Change Order, Construction Manager as Adviser Edition

PROJECT: <i>(name and address)</i> Central Hardin High School Addn/Renov Cecilia, KY	CONTRACT INFORMATION: Contract For: BP 030-12 General Trades Date: July 14, 2021	CHANGE ORDER INFORMATION: Change Order Number: 104 Date: March 13, 2024
OWNER: <i>(name and address)</i> Hardin County Board of Education 65 W A Jenkins Road Elizabethtown, KY 42701	ARCHITECT: <i>(name and address)</i> JRA Architects 3225 Summit Square Place, Suite 200 Lexington, KY 40509	CONSTRUCTION MANAGER: <i>(name and address)</i> Alliance Corporation 116 E. College Street Glasgow, KY 42141
CONTRACTOR: <i>(name and address)</i> Alliance Corporatoin 116 E College St Glasgow, KY 42142-1480

Cost associated with adding fire safety doors at gymnasium windows per COP 52R.

FIRE SAFETY CLOSURES
CENTRAL HARDIN HIGH SCHOOL
HARDIN COUNTY SCHOOLS

PR 58
1

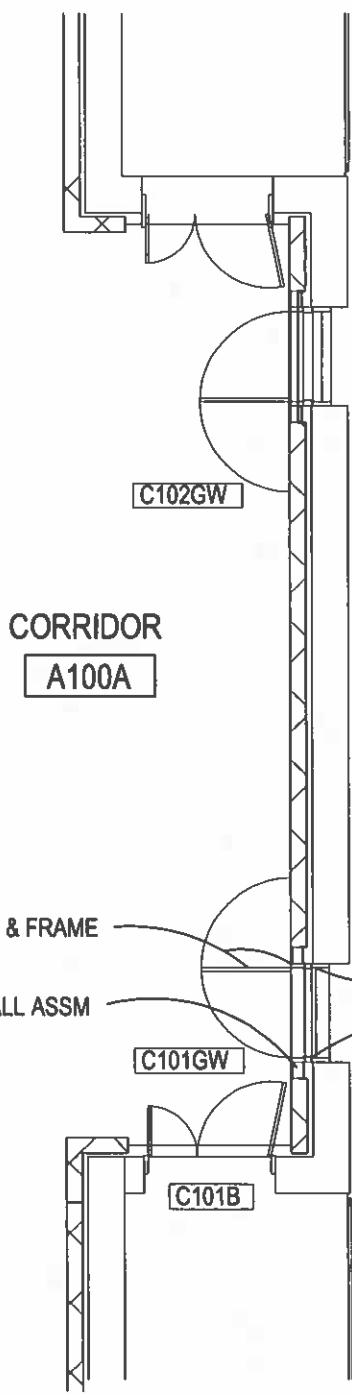
At the wall between the existing gym and the addition, provide a 3'-8" by 7'-0" HM door with 4-sided HM frame at each window location as well as new door hardware. Refer to attached drawing, PR 58-1, dated 1-15-24, and attached Hardware Set E06. Install frame in 2-hour fire rated shaftwall system using 4" studs. Install the fire rated joint system between the shaftwall and the CMU wall for the window.

Connect the magnetic hold open closers for both doors to the fire alarm system. Connect to the nearest available fire alarm circuit. Run the circuits above the lobby ceiling through the CMU wall, down the space between walls and into the head of the door frames to the closers. Install system smoke detectors located at bottom of the roof deck on the gym side of each of the 2 windows in the gym.

1. ALIGN DOOR FRAME WITH EXIST. WINDOW.
2. PROVIDE FLUSH, 3'-8" X 7'-0", 90 MIN. RATED HM DOORS.
3. PROVIDE 4 SIDED, 6-1/4" DEEP, HM FRAMES.
4. PROVIDE HARDWARE PER THE ATTACHED.
5. INSTALL FRAMES IN 2 HR RATED SHAFTWALL W/ 4" FRAMING. ALIGN FACE OF WALLBOARD W/ BACK OF RADII ON BULLNOSE BLOCK.

CLOSE THE GAP BETWEEN THE FRAMES W/ ALUM EXP JNT ANGLES

HM FRAME ELEV
MATCH WIN FR
OA DIM

Project: Central Hardin High School Reno & Addition	Code: 304776
Elevation: 4 sided	Code: 4-SIDED
Drawn by: Mack Ragoda	Date: 1/30/24 15:41
Scale: 1' 6" = 1"	Elevation Page: 1 of 1

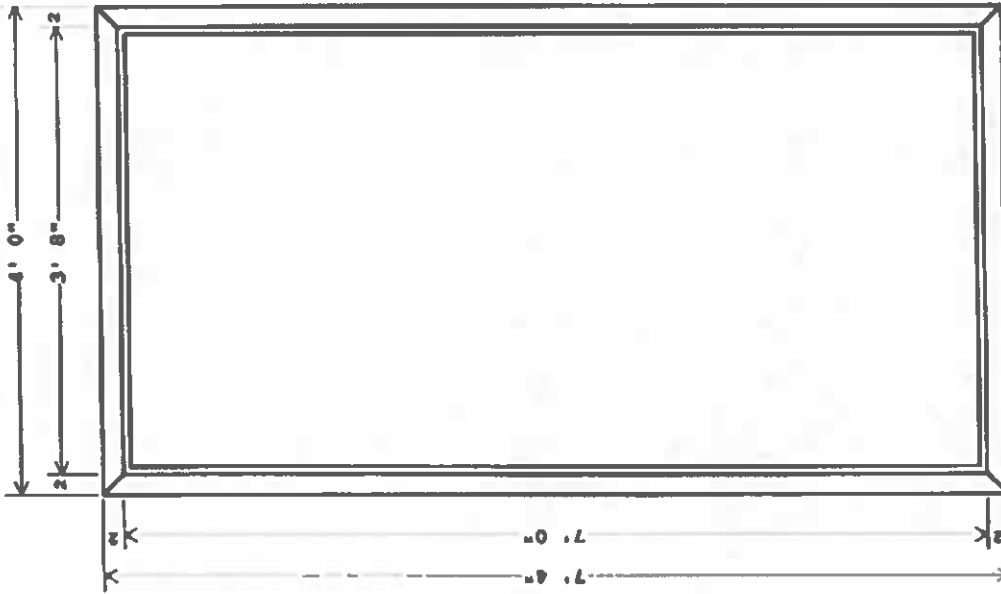
1	Single Door #C101GW	Corridor A100A from Window View		180° LHR
1	3870 1-3/4 HM W 707N B 18 CR F STY LHR (CL; G19 CH; G2)			
1	4 sided			
1	Continuous Hinge	A240HDC 85		AB
1	Lockset	9K3-7YR14D L/C	626	BE
1	Core	1C-7A2	626	BE
1	Smok Chek V Closer	0602	689	RX
1	Wall Bumper	1270CX	626	TR
2	Gasketing	700 NA 1 x 42" 2 x 86"		NA
1	Single Door #C102GW	Corridor A100A from Window View		180° RHR
1	3870 1-3/4 HM W 707N B 18 CR F STY RHR (CL; G19 CH; G2)			
1	4 sided			
1	Continuous Hinge	A240HDC 85		AB
1	Lockset	9K3-7YR14D L/C	626	BE
1	Core	1C-7A2	626	BE
1	Smok Chek V Closer	0602	689	RX
1	Wall Bumper	1270CX	626	TR
2	Gasketing	700 NA 1 x 42" 2 x 86"		NA

FIRE SAFETY CLOSURES CENTRAL HARDIN HIGH SCHOOL HARDIN COUNTY SCHOOLS			PR 58 1
PROJECT: 2018111	DATE: 1-15-24	DRAWN BY:	
			DRAWING

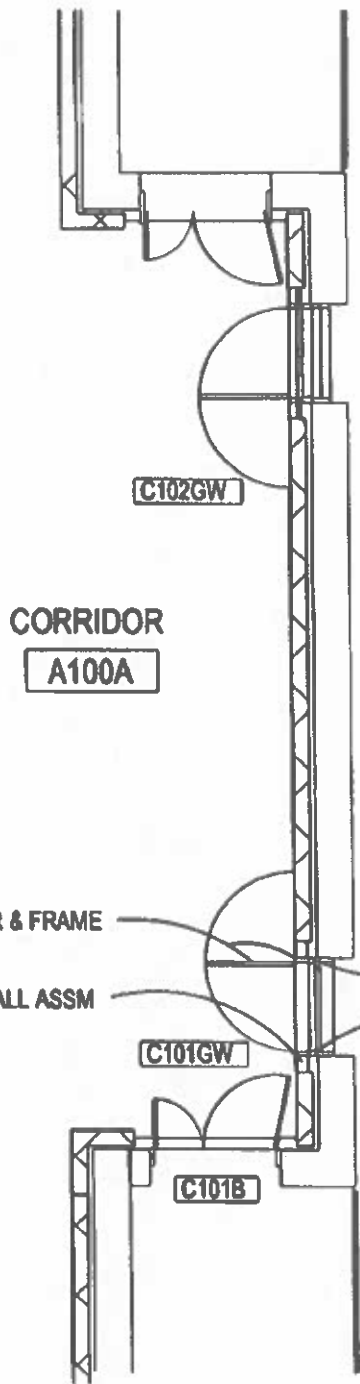
1. ALIGN DOOR FRAME WITH EXIST. WINDOW.
2. PROVIDE FLUSH, 3'-8" X 7'-0", 90 MIN. RATED HM DOORS.
3. PROVIDE 4 SIDED, 6-1/4" DEEP, HM FRAMES.
4. PROVIDE HARDWARE PER THE ATTACHED.
5. INSTALL FRAMES IN 2 HR RATED SHAFTWALL W/ 4" FRAMING. ALIGN FACE OF WALLBOARD W/ BACK OF RADI ON BULLNOSE BLOCK.

EXIST HM WINDOW
 CLOSE THE GAP BETWEEN THE FRAMES W/ ALUM EXP JNT ANGLES

HM FRAME ELEV MATCH WIN FR OA DIM
